Entergy Operations, Inc.
1448 S.R. 333
Russellville, AR 72801
Tel 501 858-5000

February 28, 2000

1CAN020008

Subject: Arkansas Nuclear One - Unit 1
Docket No. 50-313
License No. DPR-51
Supplemental Information Regarding Hot Leg Nozzle RC-1071/1072

Picture 1 of Repaired Nozzle RC-1071/1072

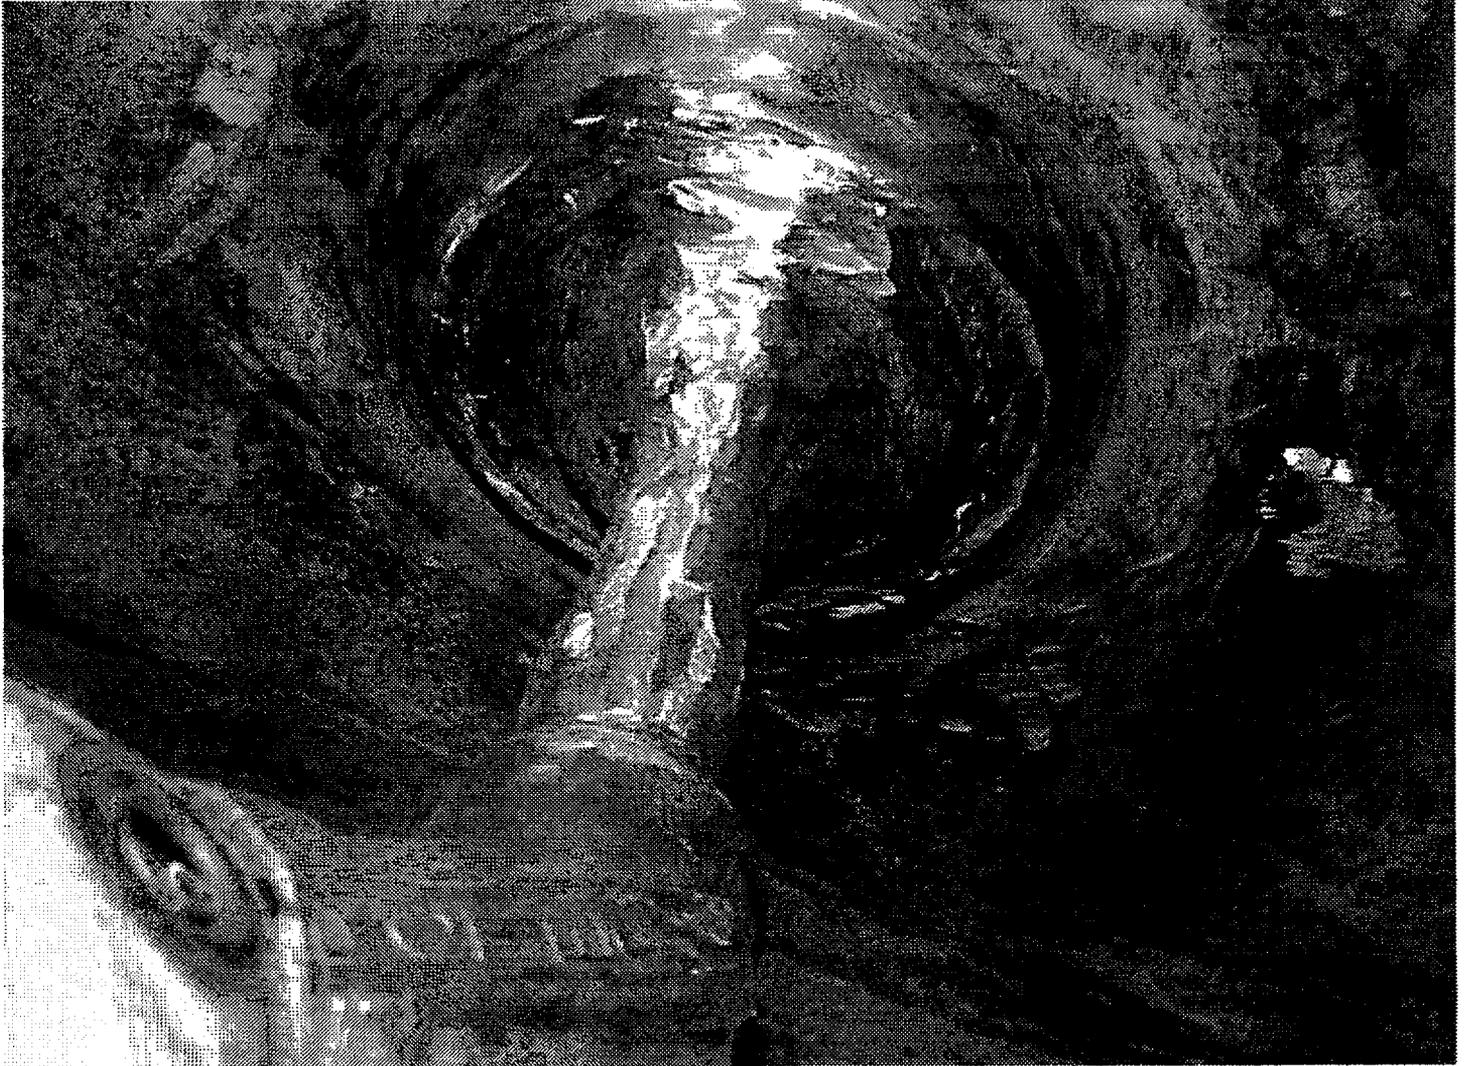
Two pictures of the new nozzle configuration are being provided for information. These pictures show a reducer which transitions the 1 inch valve to the 3/4 inch nozzle as they approach the valves as shown on our Figure 7-1 of our February 25, 2000 submittal. The wall thickness of the nozzle has not been reduced and retains its Code requirements for minimum wall thickness. The weld repair was performed using Framatome welding procedures and welders certified under their program for this welding application. Since a minimum of a 200 degree F preheat temperature was maintained during initial weld pad installation, a temper bead process was not required.

Figure C-1. Embedded Flaw Model for Weld Pad

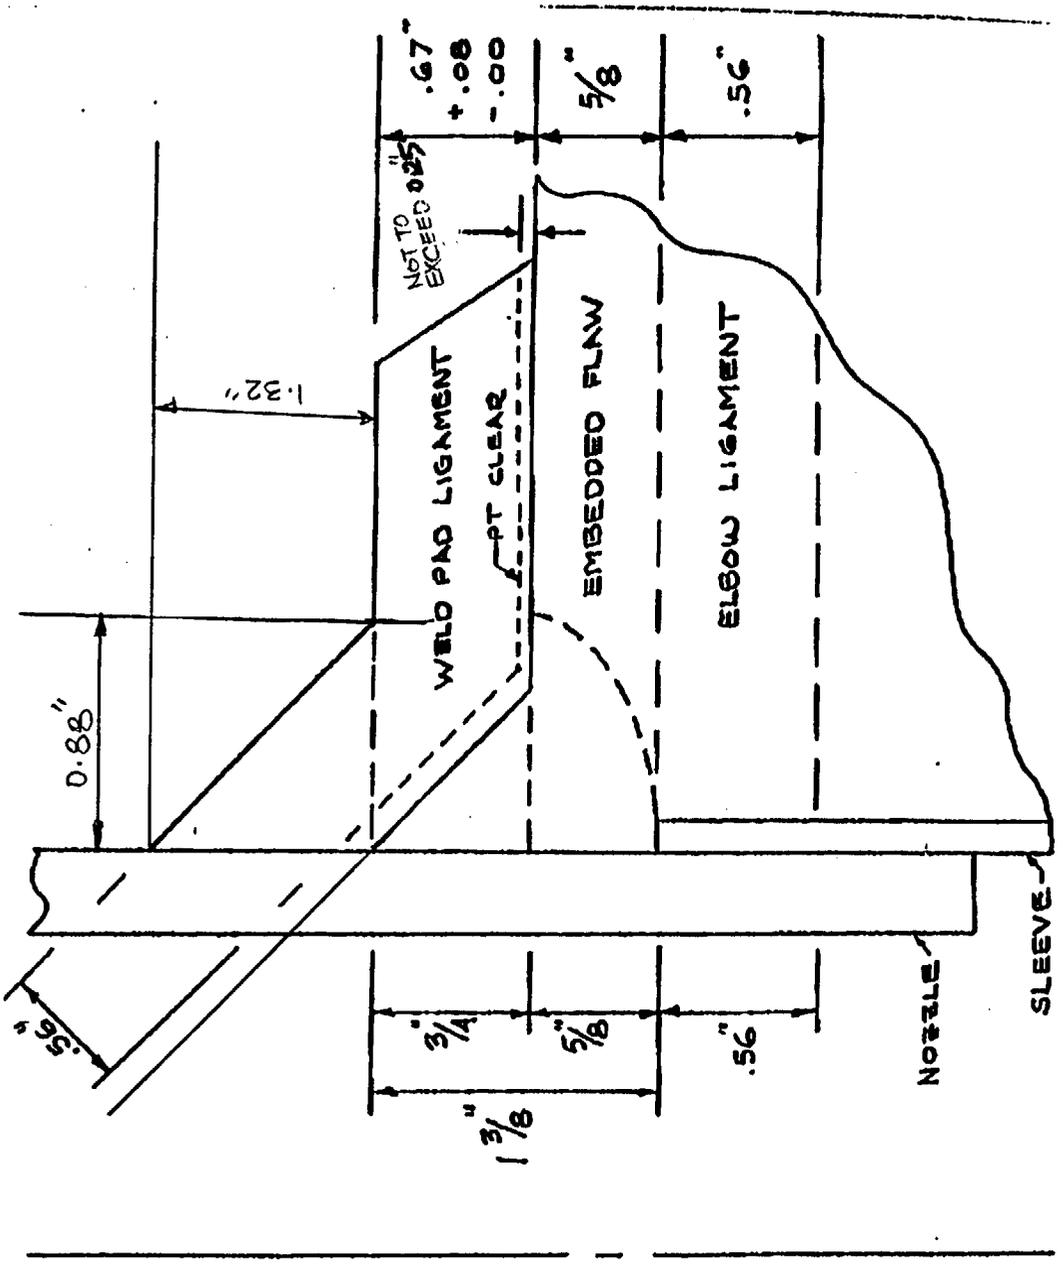
that was performed was the same as that process previously considered for the initial flaw evaluation considered by the NRC staff. The results of the additional flaw analysis resulted in the weld pad and the new fillet weld dimensions increasing. A diagram of the dimensions for the new weld is shown on Figure C-1, which is enclosed in the flaw evaluation details of Appendix C to Framatome Report 32-5007242-02 (Enclosure 2). There have been no indications that cracks exist in the nozzle itself. The inside diameters of two nozzles removed from other locations have been inspected with no indications identified.

The weld pad design proposed in our February 24 and February 25, 2000 submittals increased from 0.62 inch to 0.75 inch and the fillet weld increased from 0.5 inch weld with a 2:1 taper to an approximate 0.88 inch weld with a 1.5:1 taper. The weld pad buildup, and the increased weld height (along the nozzle axis) will serve to stiffen the nozzle. This taper is considered acceptable based on the same EPRI report (EPRI Report TR-107455) that provides a quantitative estimate of the improvement with a 2 to 1 taper and notes that any increases in the length of the axial leg improve vibration resistance. The EPRI study did not quantify the amount of improvement for increases over 1 to 1, other than to note that they exist, and to suggest further quantification of the amount as one of the areas for potential further study. Entergy did not credit either the initial 2:1 taper or the revised 1.5:1 taper in the quantitative vibrational analysis. Prior to weld pad buildup, the assembly exhibited a first bending mode at 25.5 hertz and a torsional mode was also experienced at 21.7 hertz. After welding was completed, the first bending mode had increased to 31.9 hertz and the torsional mode increased to 22.5 hertz. This moves the frequency further away from the motor running speed vibrations present at approximately 20 hertz, and will reduce the vibrational stresses accordingly.

An embedded flaw is postulated to be present between the elbow and the weld pad. This flaw can be considered to be a compound flaw formed by the 5/8" deep J-groove flaw, analyzed for the carbon steel elbow material (Table 1), and the triangular shaped area inside the PT clear profile shown in Figure C-1 [1,12]. The PT clear line, which is outside the original fillet weld, is truncated by the line along the top of the weld pad at 3/4" above the elbow surface. The total depth of the postulated flaw is the sum of the 5/8" deep J-groove and the 3/4" high triangular void, or 1 3/8". The specified thickness of the weld ligament in the region is 0.56", and since the design thickness of the pad is 1/2", there is a 0.060" allowance for crack growth. Although there is about 3" of elbow base metal below the flaw, only 0.56" will be credited to create a symmetric center cracked panel (CCP) model.

Using conservative analysis, it is predicted that the postulated embedded flaw would grow 0.042 inch over a fuel cycle. This amount of crack growth is within the 0.060 inch layer of sacrificial material included in the design of the weld pad.
